PVNGS UNIT 1

**MARKED UP TECHNICAL SPECIFICATIONS
TO SUPPORT NRC GENERIC LETTER 88-16**

FIGURE 1

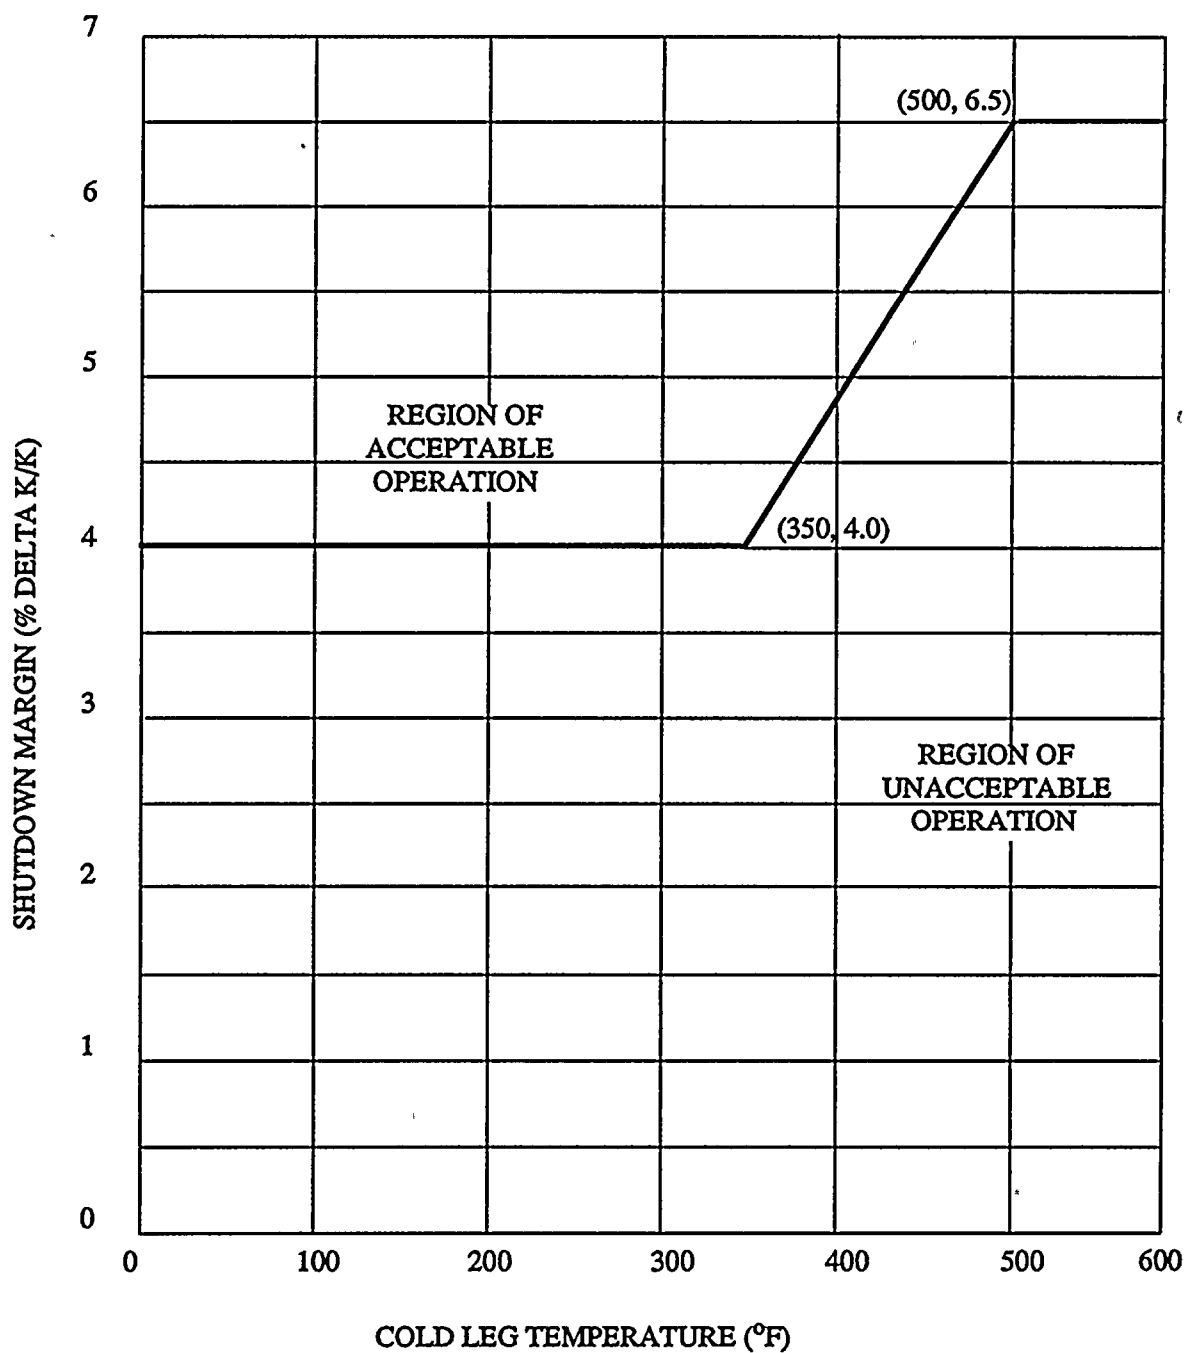
The Shutdown Margin shall be greater than or equal to that shown in Figure 1.

FIGURE 2 - ALLOWABLE MTC MODES 1 AND 2

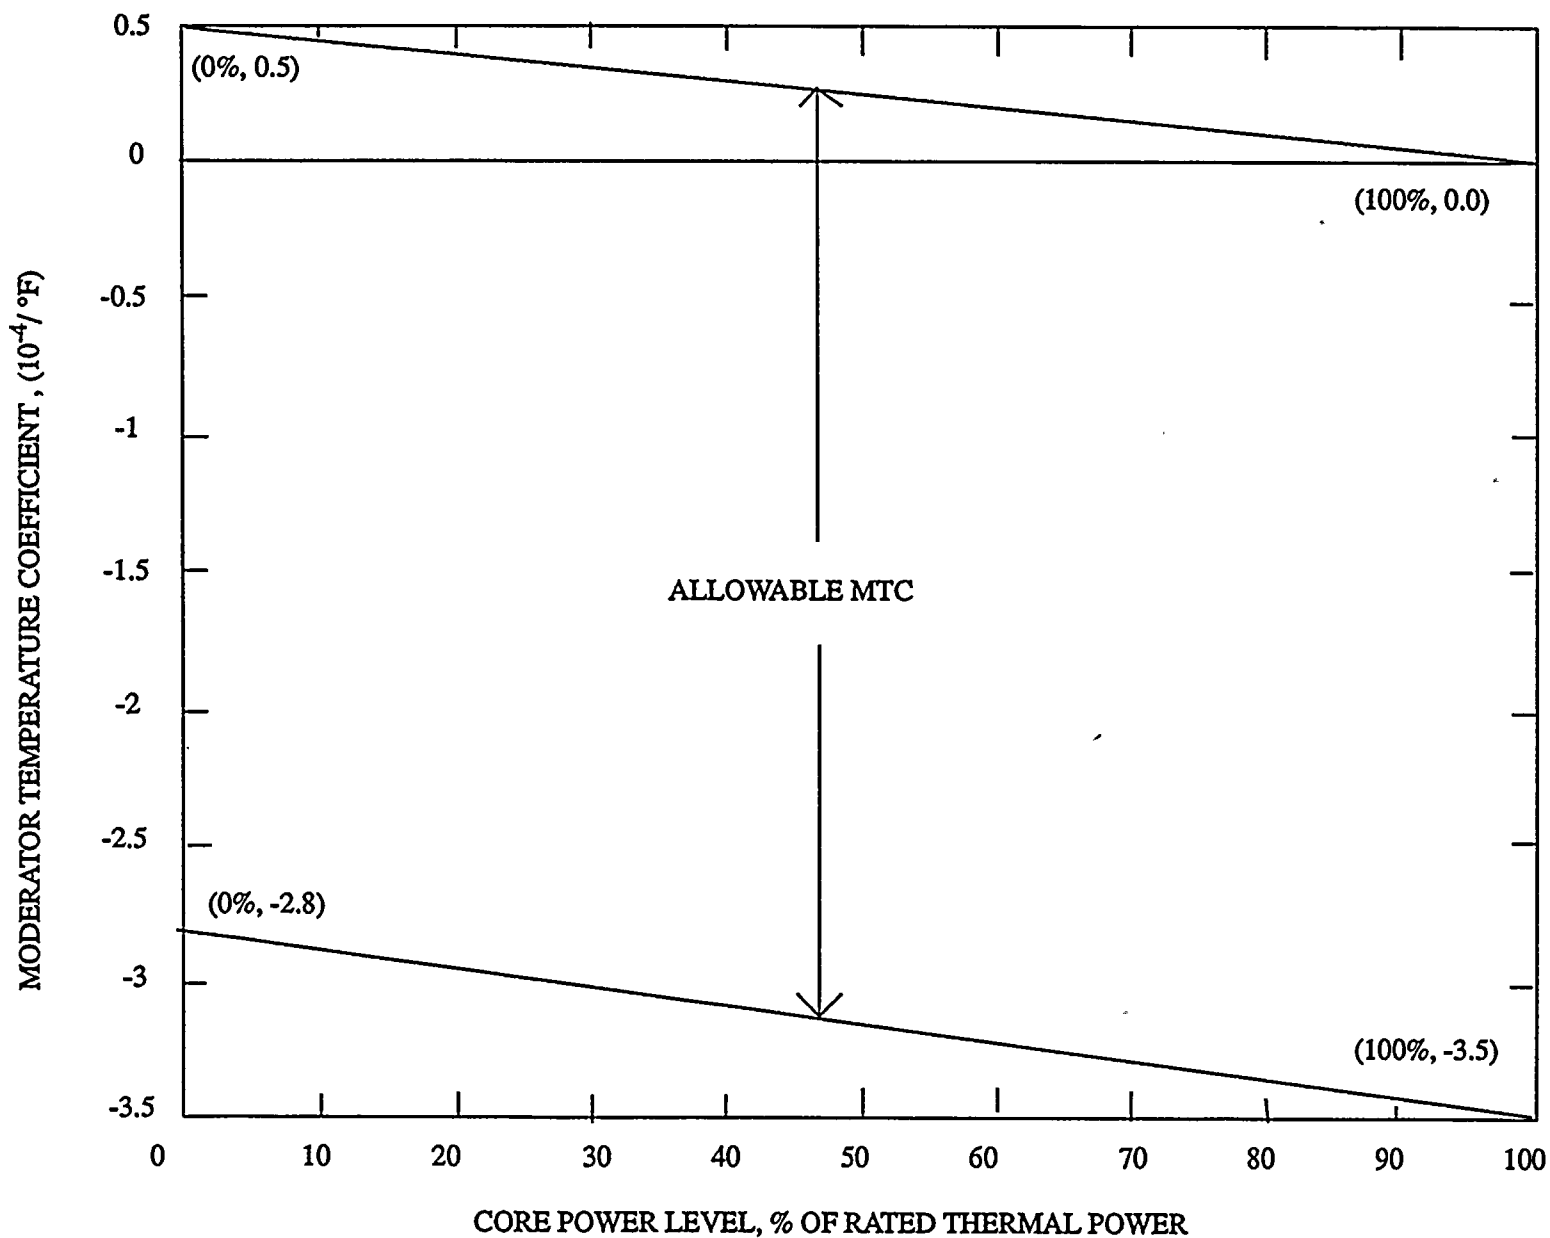
The moderator temperature coefficient (MTC) shall be within the area of Acceptable Operation shown on Figure 2.

FIGURE 3

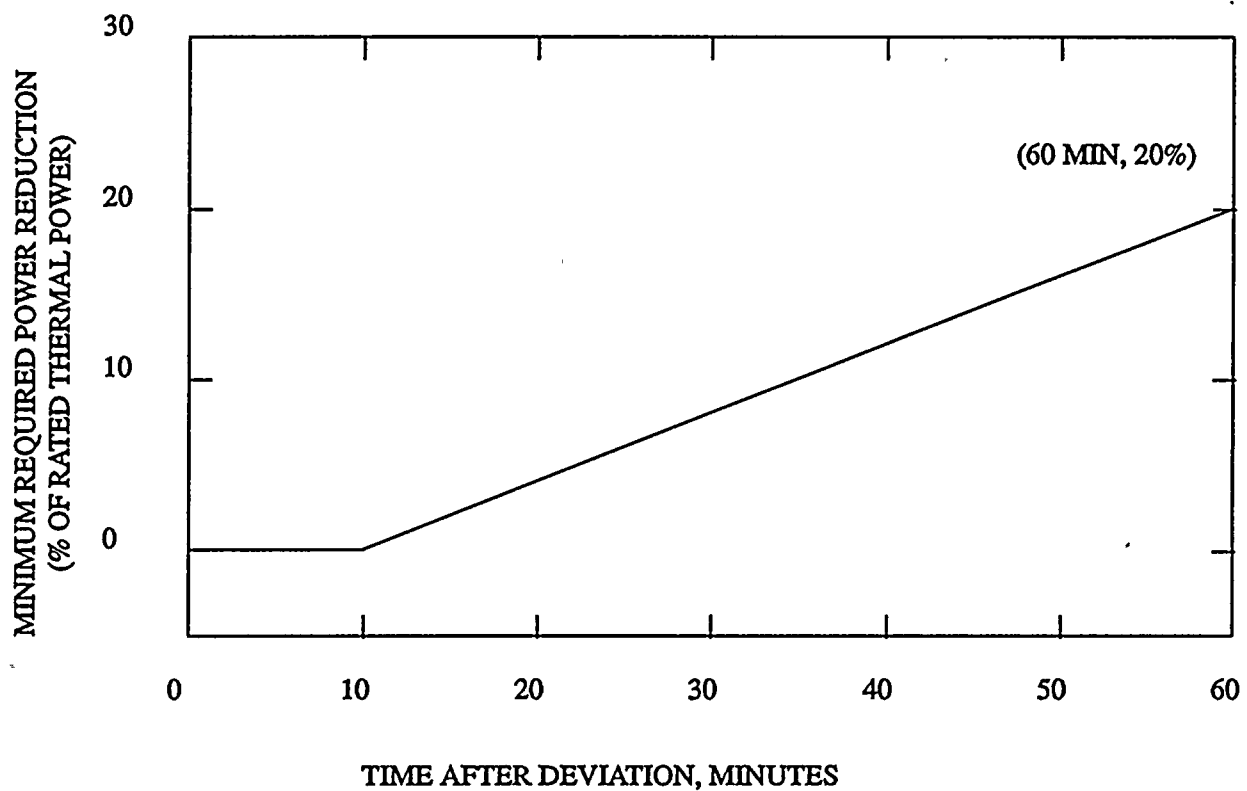
With one or more full-length or part-length CEAs misaligned from any other CEAs in its group by more than 6.6 inches, the minimum required MODES 1 and 2 core power reduction is specified in Figure 3.

FIGURE 4
CEA INSERTION LIMITS VERSUS THERMAL POWER
(COLSS IN SERVICE)

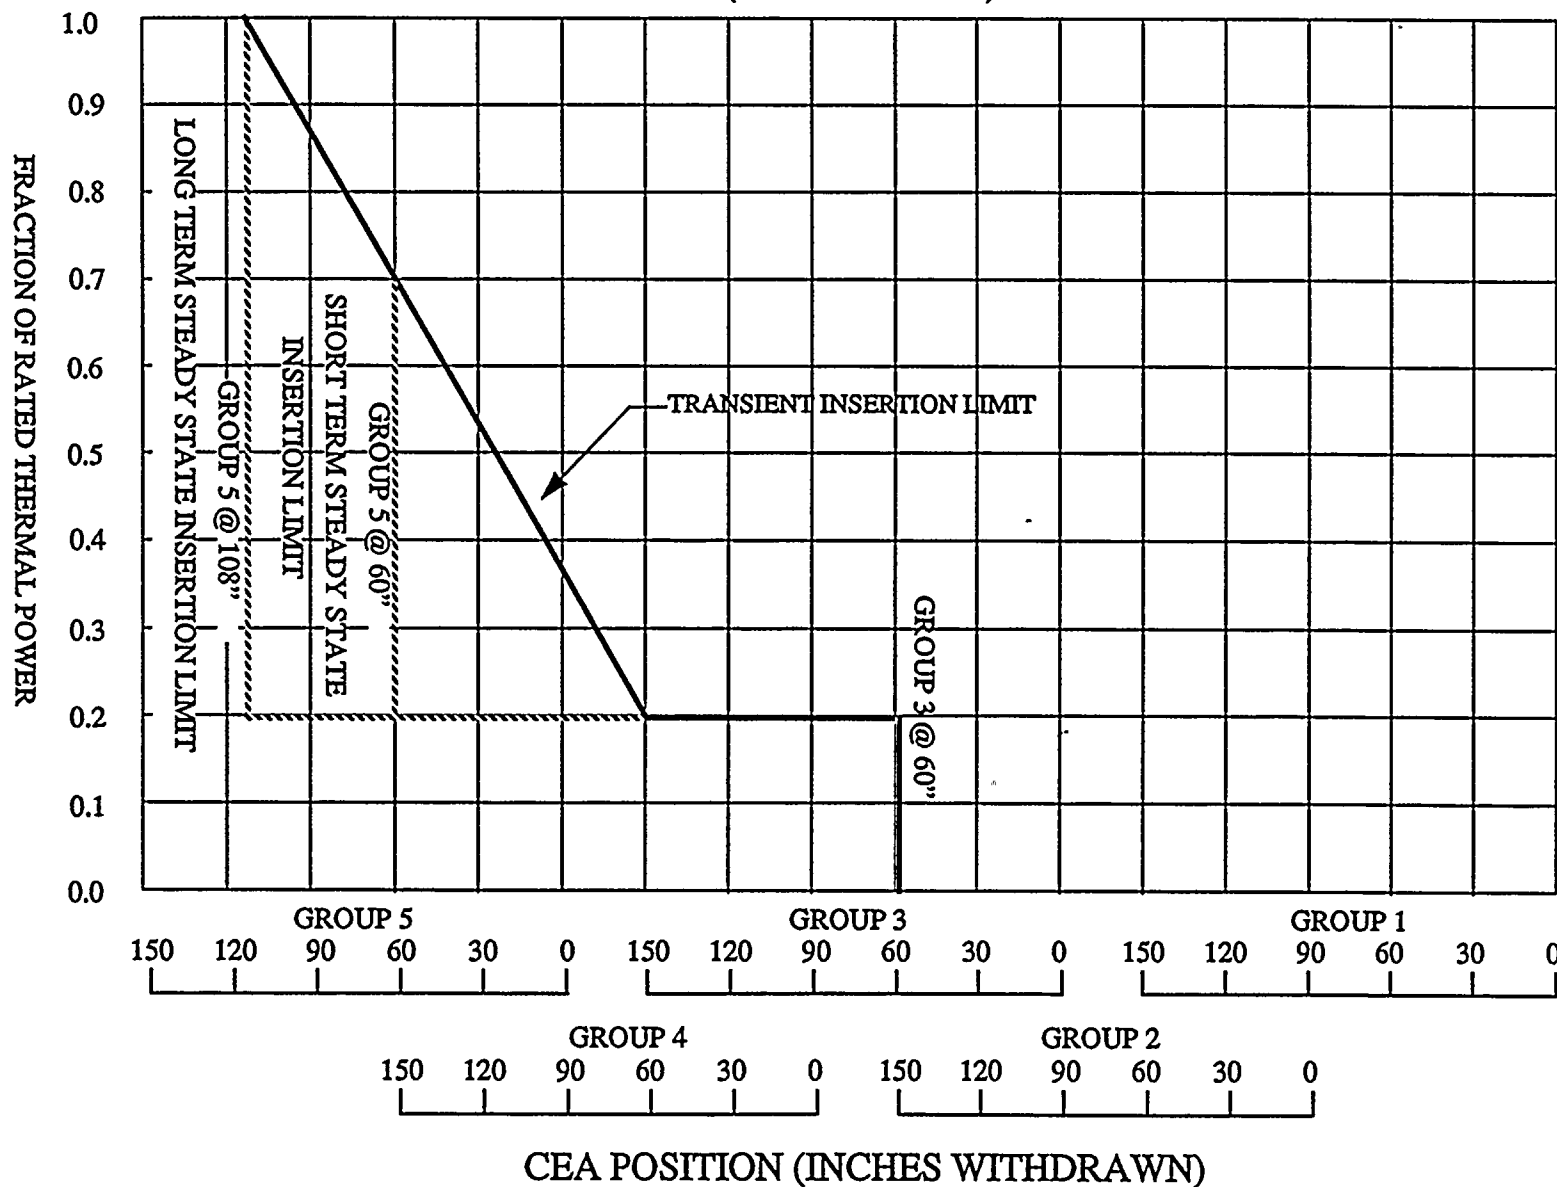
One or more CEAC's OPERABLE: The regulation CEA groups shall be limited to the withdrawal sequence and to the insertion limits shown on Figure 4 when the COLSS is IN SERVICE or shown on Figure 5 when the COLSS is OUT OF SERVICE.

FIGURE 6

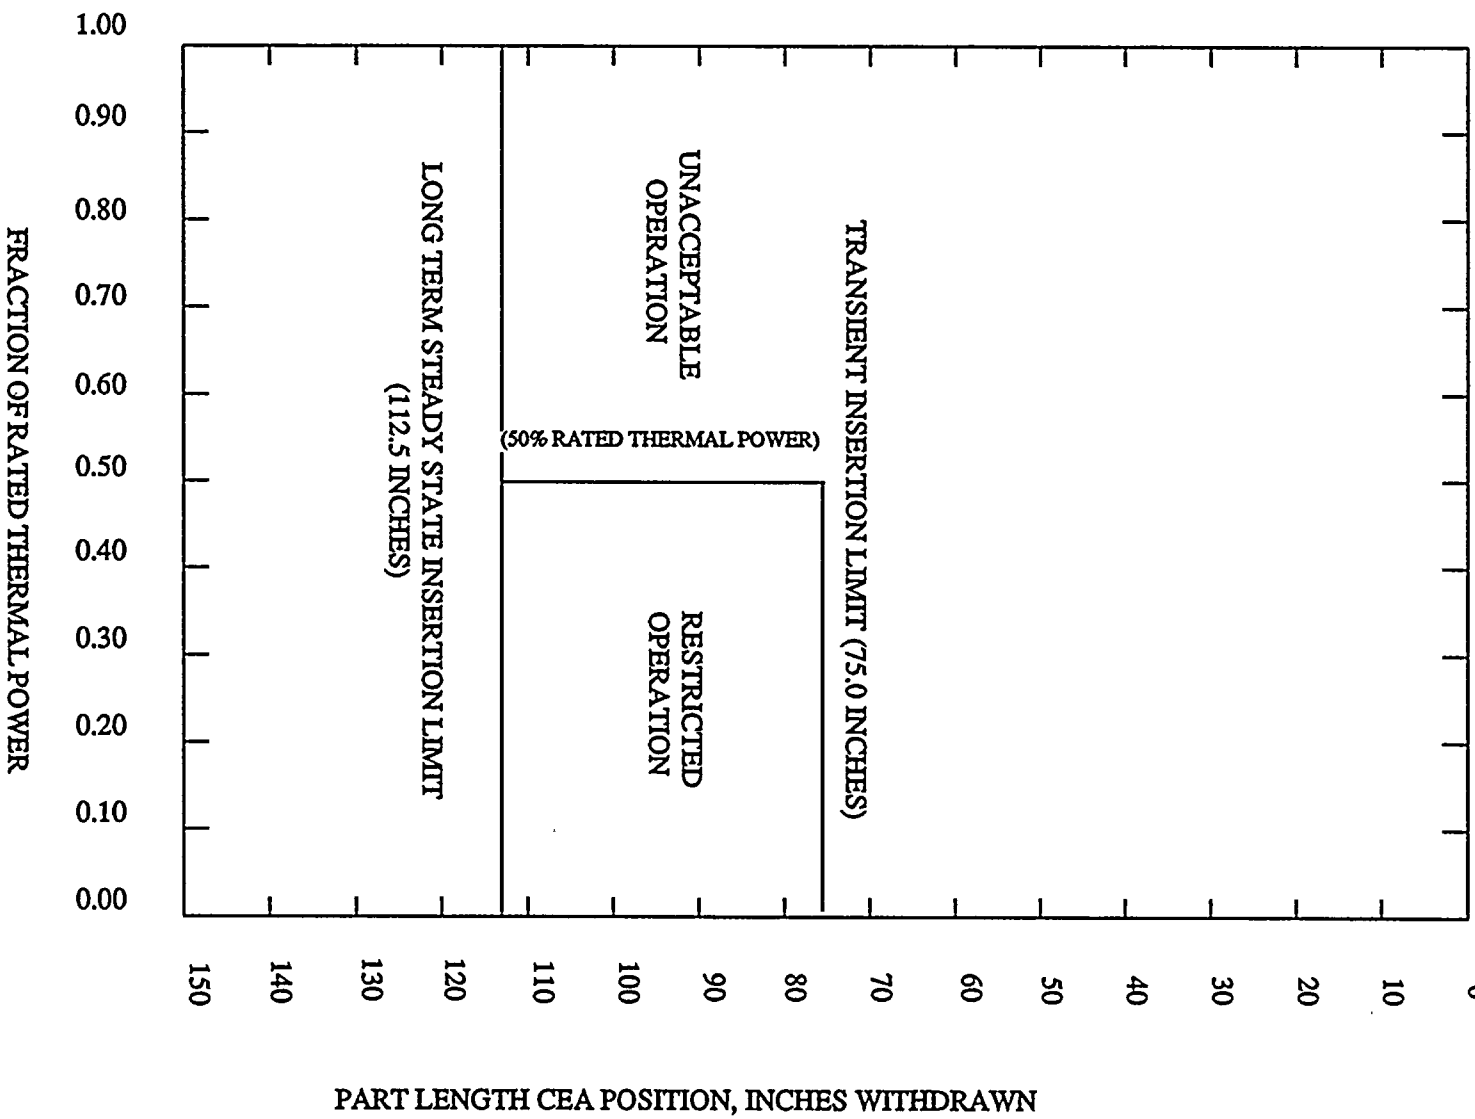
One or more CEAC's OPERABLE: The part length CEA groups shall be limited to the insertion limits shown on Figure 6.

FIGURE 7

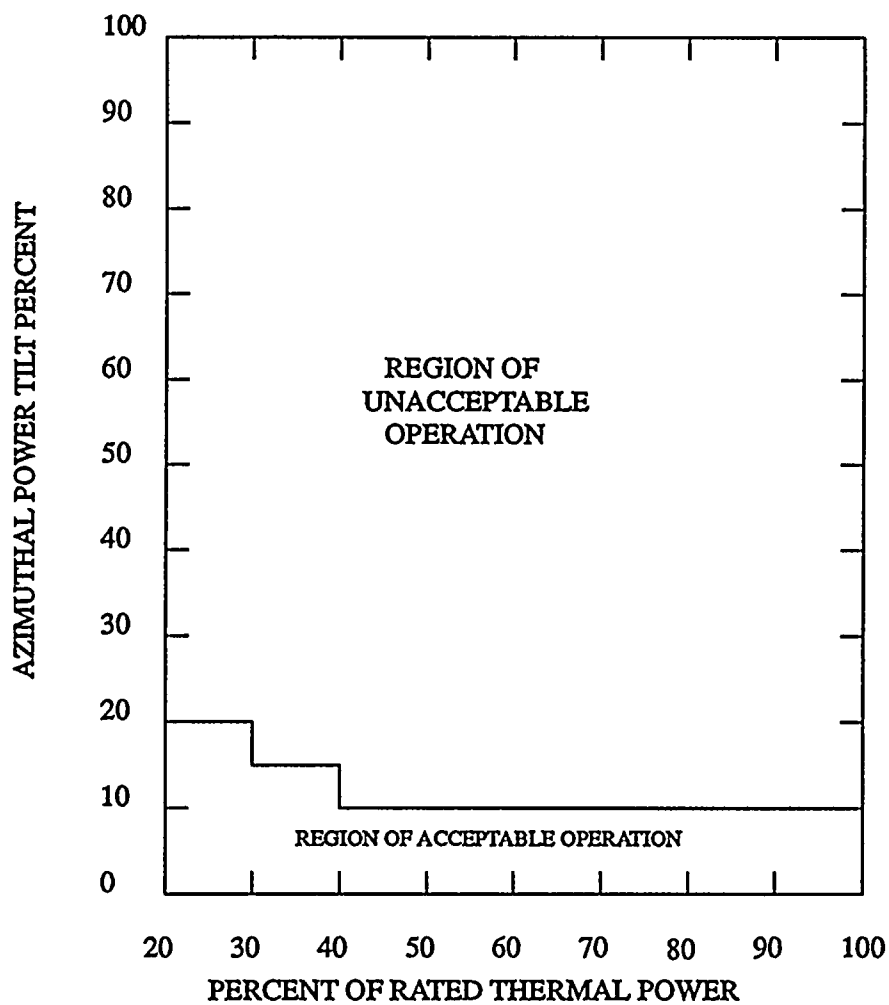
The AZIMUTHAL POWER TILT (T_q) shall be less than or equal to the limit in Figure 7 with COLSS IN SERVICE.

FIGURE 8

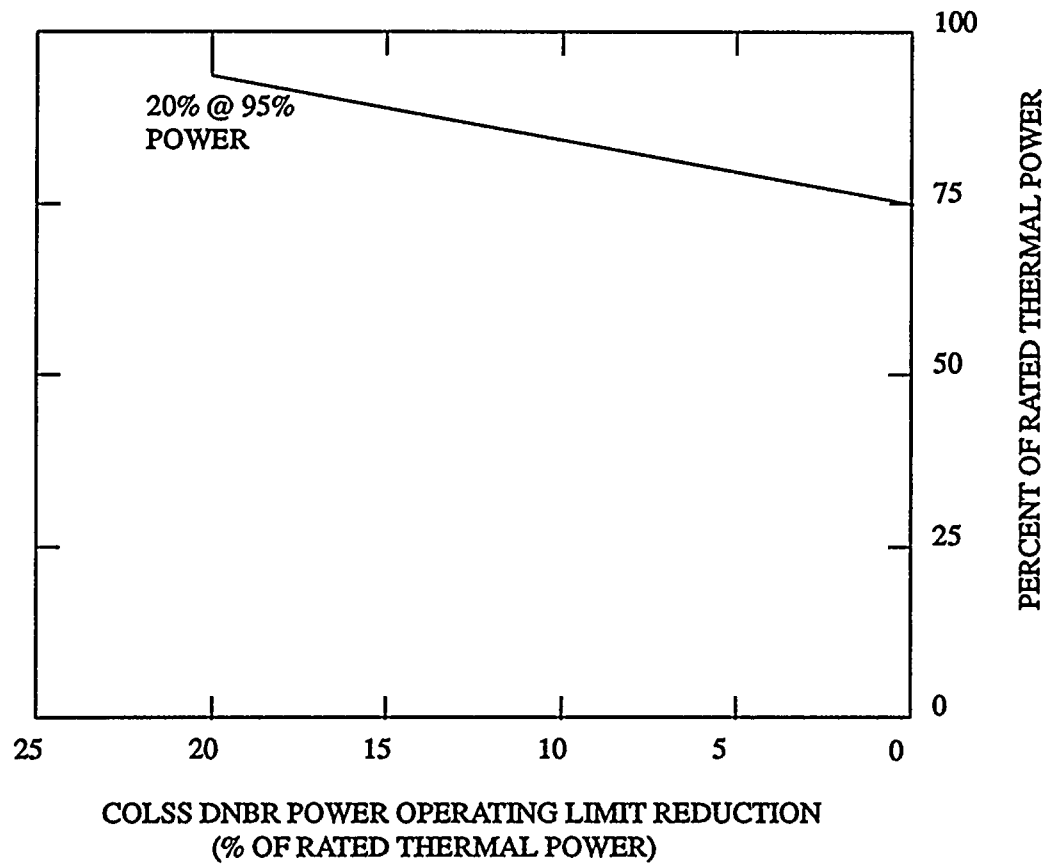
COLSS IN SERVICE and Both CEAC's INOPERABLE - Maintaining COLSS calculated core power less than or equal to COLSS calculated core power operation limit based on DNBR decreased by the allowance shown in Figure 8.
